TRUCK, UTILITY, LIGHTWEIGHT, MC2 LAND ROVER 110 - ALL TYPES  
TRUCK, CARGO, LIGHT, MC2 LAND ROVER 110 - ALL TYPES

FITTING OF AN EXTRA EARTH STRAP

MODIFICATION INSTRUCTION

FIG 1 - EARTH STRAP MOUNTING

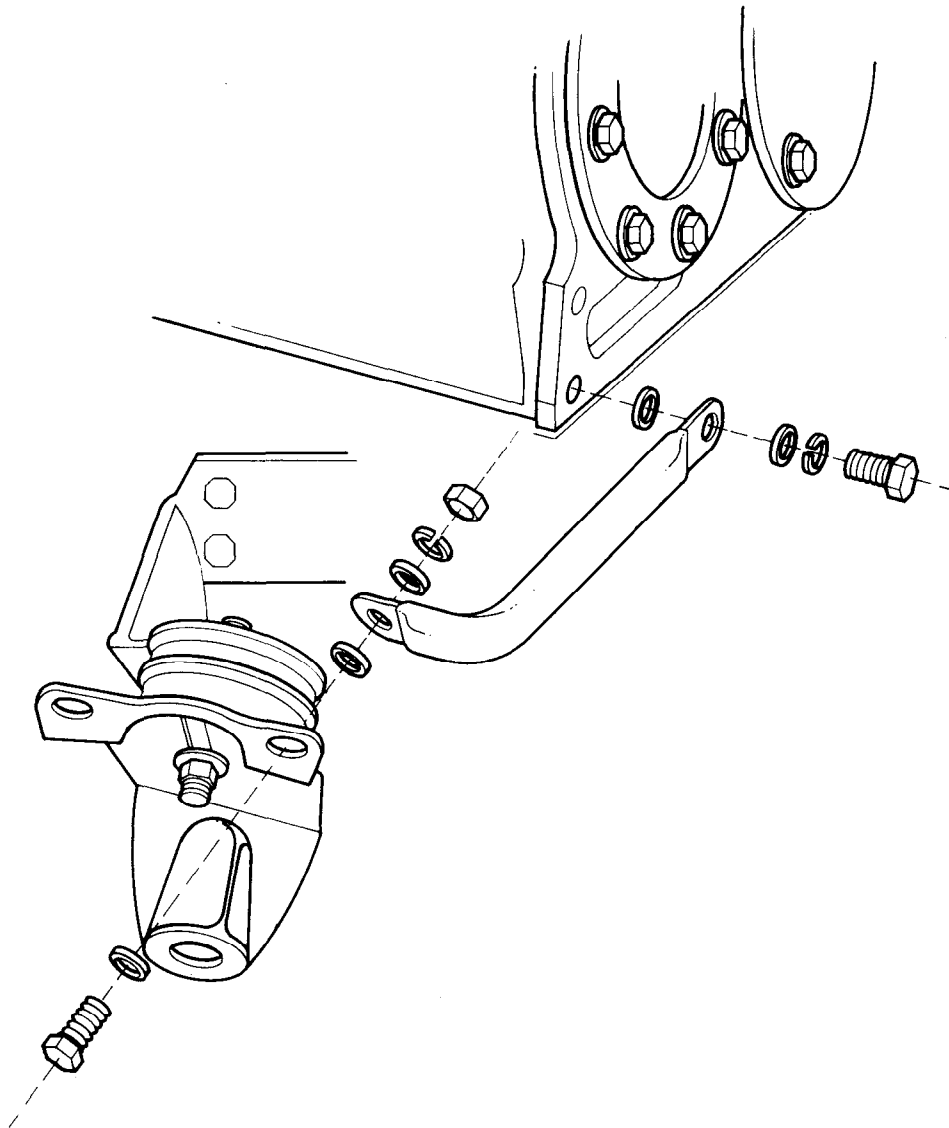
1. This instruction details the fitting of an extra earth strap to provide an additional earthing point at the rear of the transmission.

7. The modification is to be carried out as follows:
  - a. Using the existing bolt on the 4x4 Landrover, fit one end of the earth strap (Item 1 from Table 1) to the top rear bolt of the transmission mount as shown in Fig 1.
  - b. On the 6x6 Landrover, remove the top rear bolt of transmission mount and discard. Replace with item 5 from Table 1 and fit one end of the earth strap using items 1 and 4 as shown in Fig 1.

- c. Fit the other end of the lead to the rear of the transmission using items 2, 3 and 4 from Table 1, as shown in Fig 1.
